Technical Service Bulletin

Subject: UNUSUAL NOISE WHEN STARTING TO MOVE VEHICLE WHILE STEERING WHEEL IS FULLY TURNED TO DRIVER-SIDE	Bulletin No.: 06-001/19
	Last Issued: 02/04/2019

This bulletin supersedes the previously issued bulletin(s) listed below. The changes are noted in Red text.

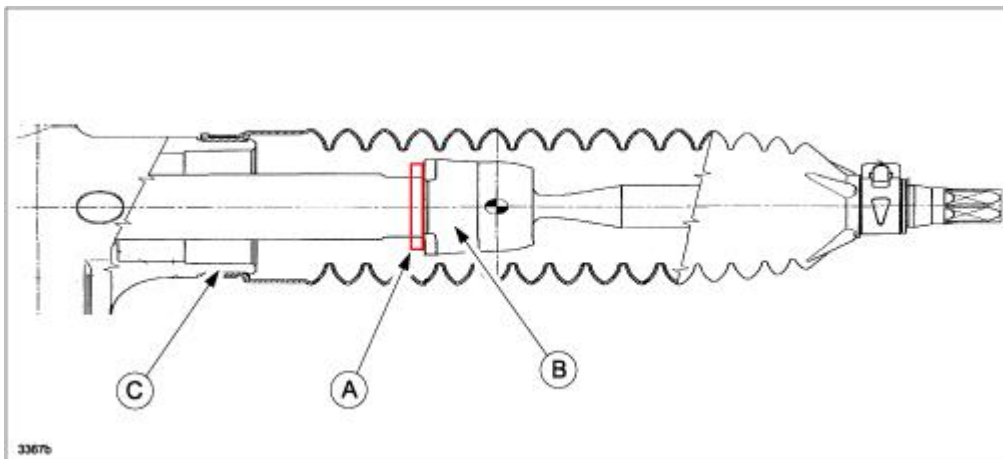
The noise is caused when the edge (A) of the inner ball joint (B) gets stuck with the steering gear housing (C).

To eliminate the noise, a spacer (A) has been installed between the inner ball joint (B) and the steering gear housing (C) (both sides) to prevent direct contact.

DRIVER SIDE

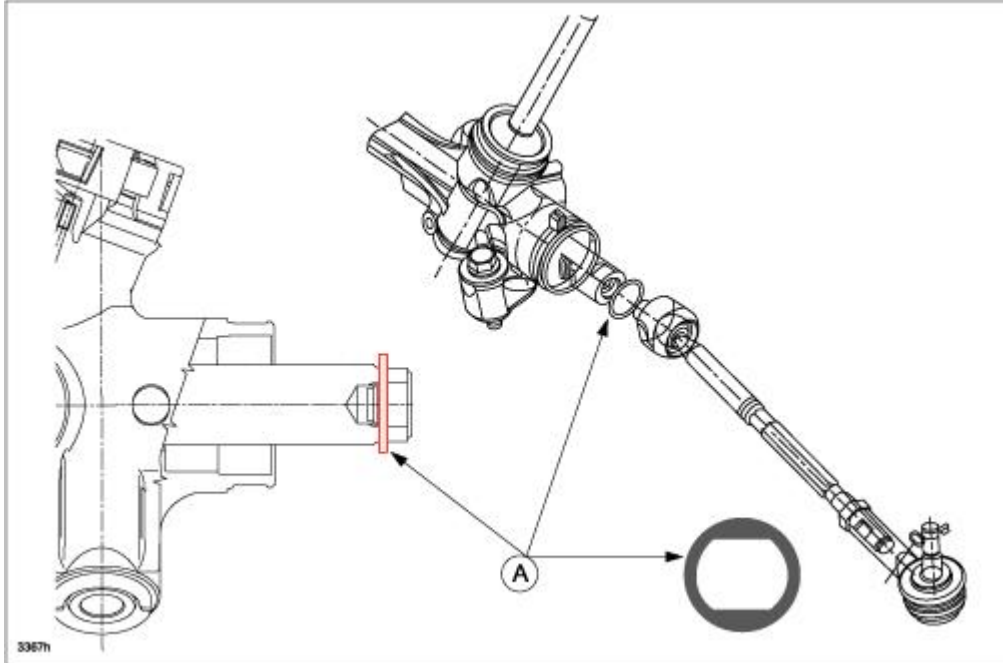
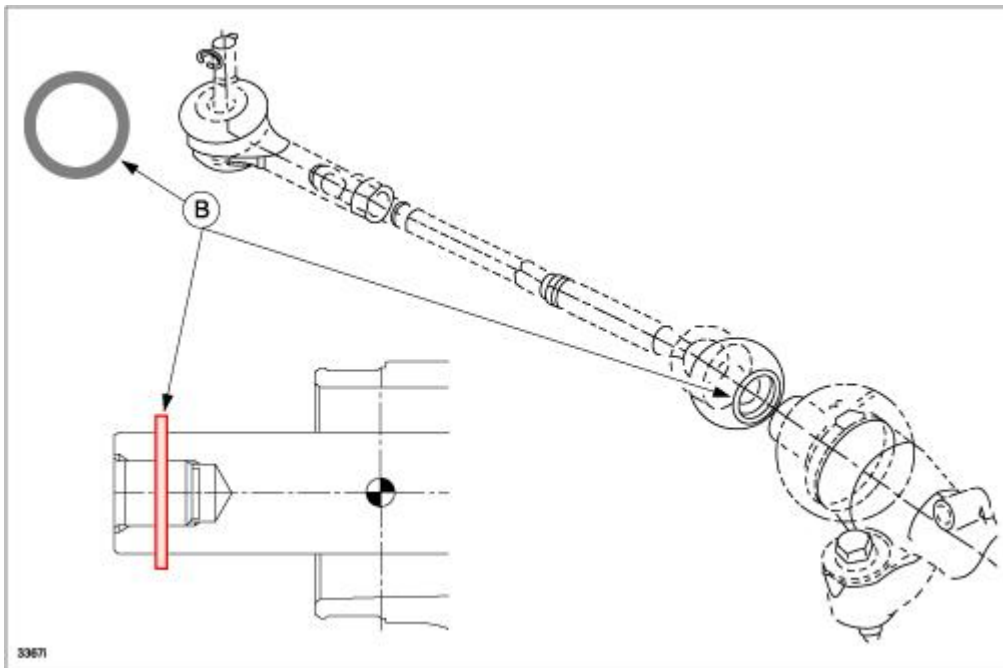
5. Install the driver side spacer (A) and passenger side spacer (B) onto the steering rack bar as shown below.

NOTE: Be aware that the shape of the driver and passenger side spacers are different.

NOTE: Both sides of each spacer are the same. There is no back or front side.
